SERVICE BULLETIN

N° **189-291**

ATA 25 - LOWER WIRE STRIKE PROTECTION SYSTEM KIT INSTALLATION

This Service Bulletin is issued in order to provide the necessary instructions on how to install the “kit lower wirestrike protection system” P/N 8G9540F00211.

Figure 7

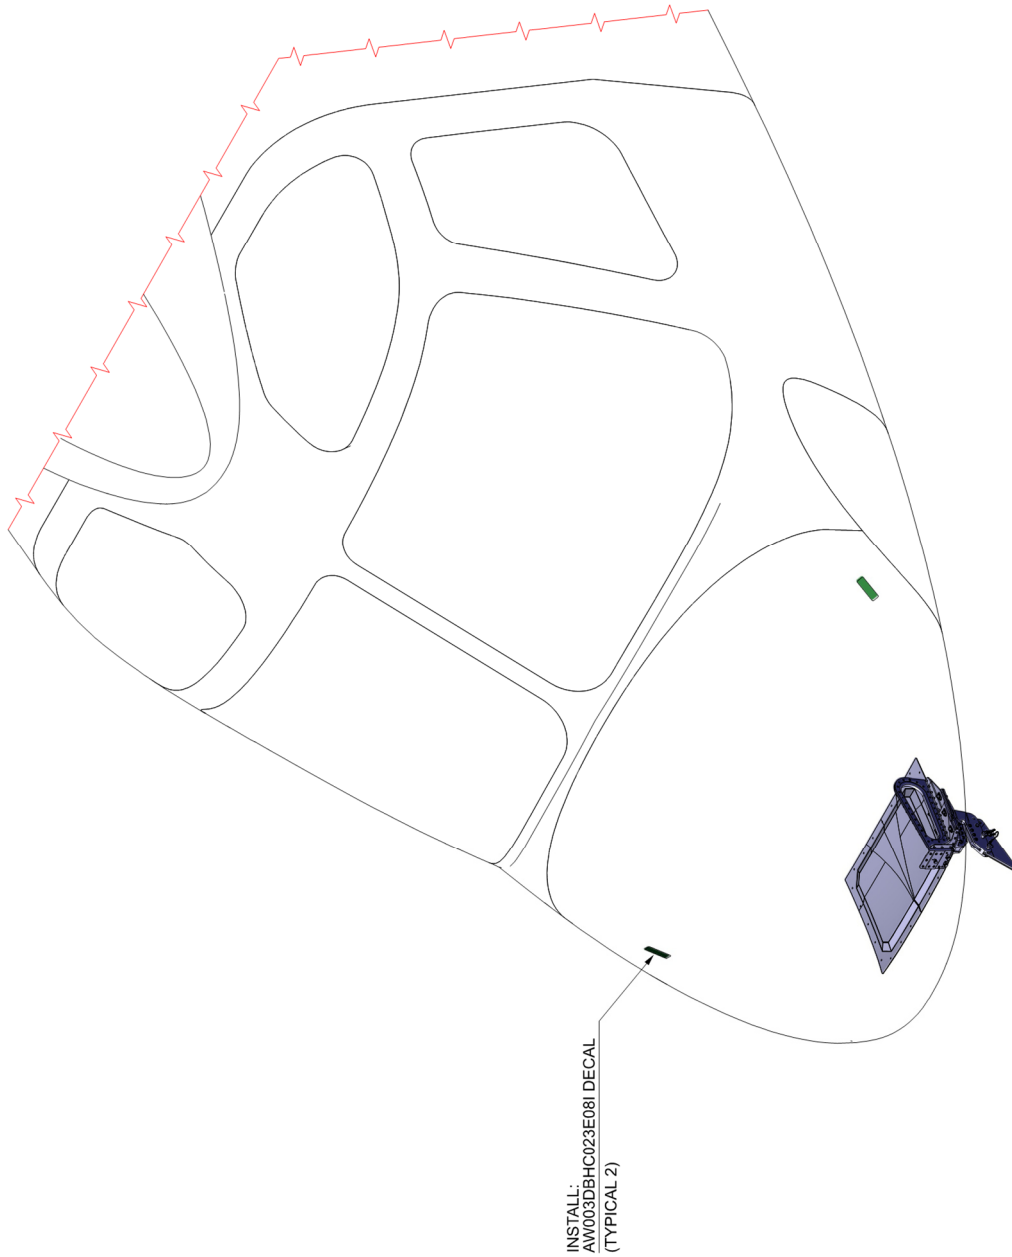
- 2.5 With reference to Figure 6 View B, paint the indicated surface with 11136 red colour.
3. With reference to Figure 7, perform “Markings Lower Wire Strike” P/N 8G1120A18311 as described in the following procedure:
 - 3.1 In accordance with DM 89-A-11-00-01-00A-720A-A and with reference to Figure 7, apply n°2 decals P/N AW003DBHC023E08I in indicated positions.
4. In accordance with weight and balance changes, update the Chart A (see Rotorcraft Flight Manual, Part II, section 6).
5. Return the helicopter to flight configuration and record for compliance with Part II of this Service Bulletin on the helicopter logbook.
6. Gain access to My Communications section on Leonardo WebPortal and compile the “Service Bulletin Application Communication”.
